**The W Nursing School
Neshoba General
Philadelphia, MS**

Addendum No. 4

June 15, 2026

This addendum forms a part of the contract documents and modifies the original plans and specifications dated June 4, 2026.

2 WALL SECTION - NORTH WALL
1" = 1'-0"

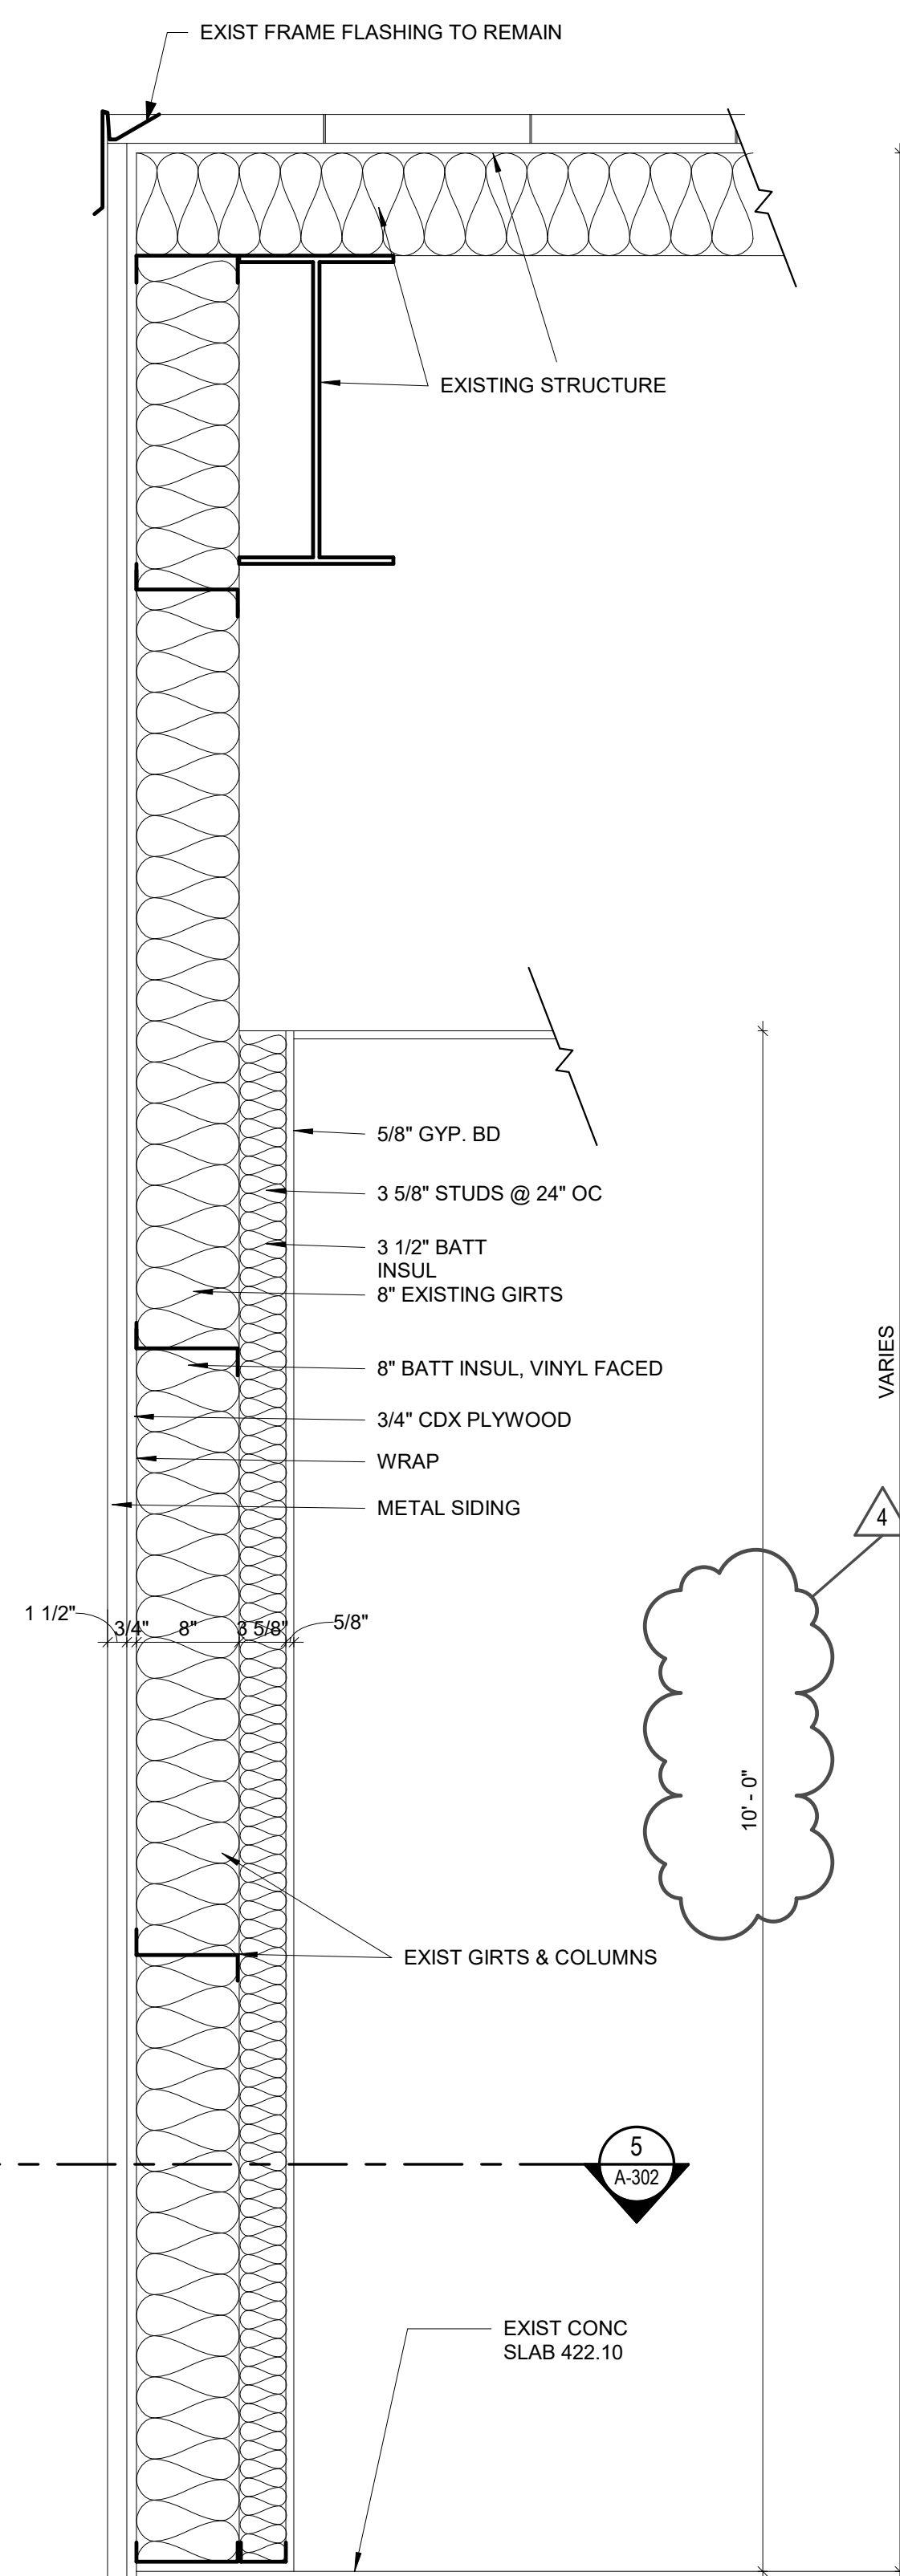
Note: Detail No. 1 clarifies new face brick at existing CMU exterior wall at east façade.
Detail No. 2 indicates new 6” stud wall with face brick at east wall between column lines G and H.
